Office Action Summary	Application No. 10/772,460	Applicant(s) MEYER, SIEGFRIED	
	Examiner Vinh T. Luong	Art Unit 3682

5. Claims 1-5 are rejected under 35 U.S.C. 102(b) as being anticipated by Anthony (US Patent No. 2,217,721).

ATTACHMENT

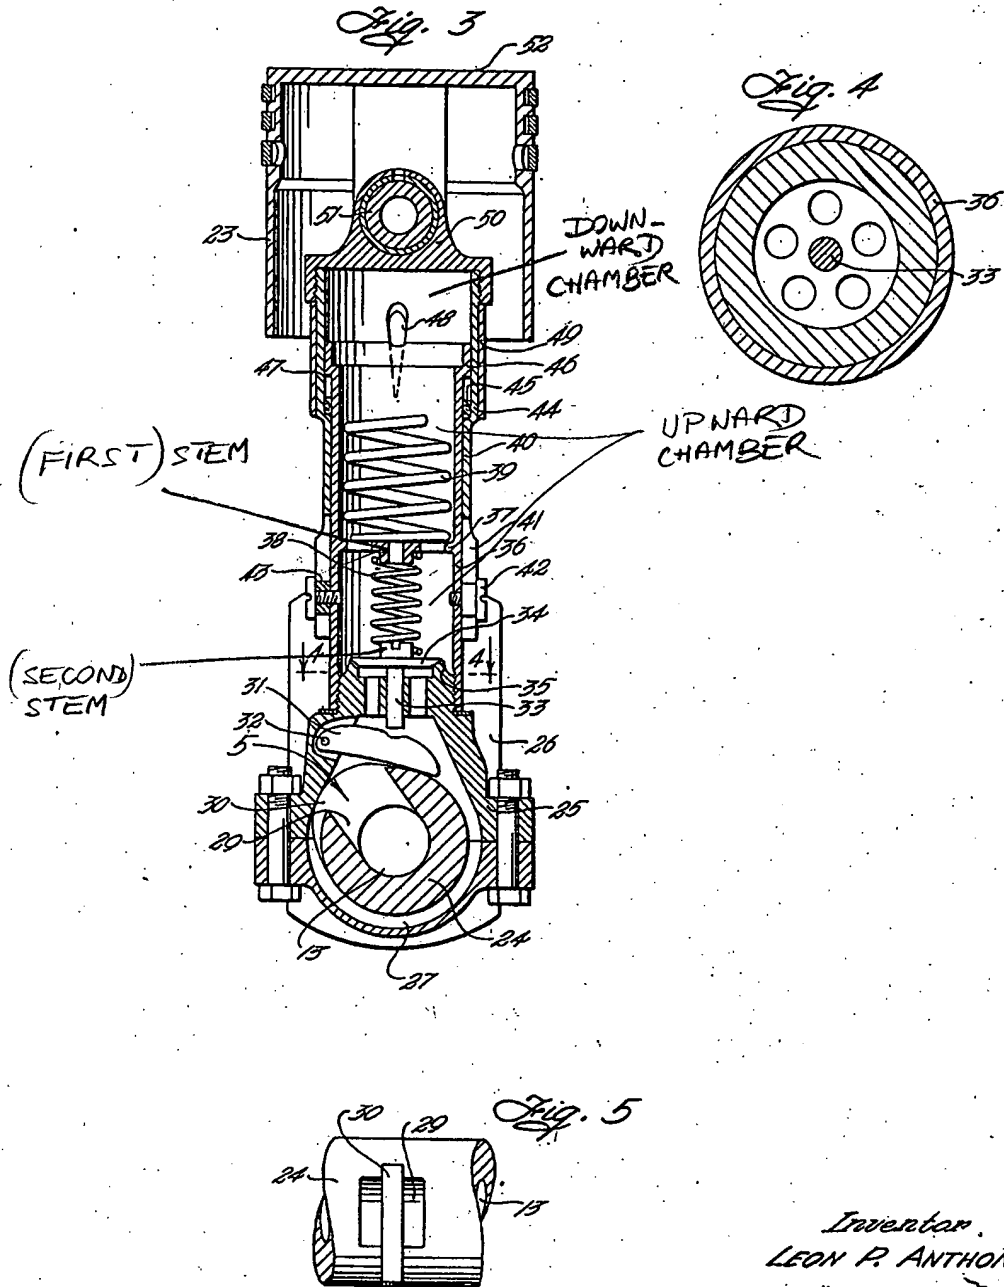
Regarding claim 1, Anthony teaches a spring-based crankshaft coupling structure used in an engine and coupled between a piston 23 and a crankshaft 24 to enhance the output torque of the engine, comprising:

a first coupling member 50, 49, 40 pivoted to said piston 23, said first coupling member comprising a downwardly extended receiving open chamber (unnumbered in Figs. 1 and 3. See Attachment or "Att.") defined in a downwardly extended hollow body 49 thereof and an inner tube 40 suspended in said downwardly extended receiving open chamber inside said downwardly extended hollow body 49;

a second coupling member 25, 36 pivoted to said crankshaft 24, said second coupling member 25, 36 comprising an upwardly extended hollow body 36 inserted into the downwardly extended receiving open chamber (Att.) and axially movably sleeved onto said inner tube 40, and an upwardly extended receiving open chamber (Att.) defined in said upwardly extended hollow body 36 thereof and adapted to receive said inner tube 40; and

an axially compressible spring member 39 or 38 mounted in said inner tube 40 inside said first coupling member 50, 49, 40 and coupled between said first coupling member 50, 49, 40 and said second coupling member 25, 36. See page 2, right column, line 37 through page 3, left column, line 15.

Regarding claim 2, said first coupling member 50, 49, 40 comprises a (first) stem (Att.) coaxially suspended inside said inner tube 40; said second coupling member 25, 36 comprises a (second) stem (Att.) suspended in said upwardly extended receiving open chamber (Att.) and aimed at the (first) stem (Att.) of said first coupling member 50, 49, 40; said axially compressible spring member 38 has two ends respectively fastened to the (first) stem (Att.) inside said first coupling member 50, 49, 40 and the (second) stem (Att.) inside said second coupling member 25, 36.

Regarding claim 3, stop means, such as, e.g., 48 is adapted to limit the distance of axial movement of said second coupling member 25, 36 relative to said first coupling member 50, 49, 40. See page 3, right column, lines 53-65.

Regarding claim 4, said stop means comprises a first annular stop flange 44 radially inwardly protruded from a bottom end of the hollow body 49 of said first coupling member 50, 49, 40 and disposed in contact with the periphery of the hollow body 36 of said second coupling member 25, 36, and a second annular stop flange 46 radially outwardly protruded from a top end of the hollow body 36 of said second coupling member 25, 36 and disposed in contact with an inside wall of the hollow body 49 of said first coupling member 49. See Fig. 3 and page 2, right column, lines 50-74.
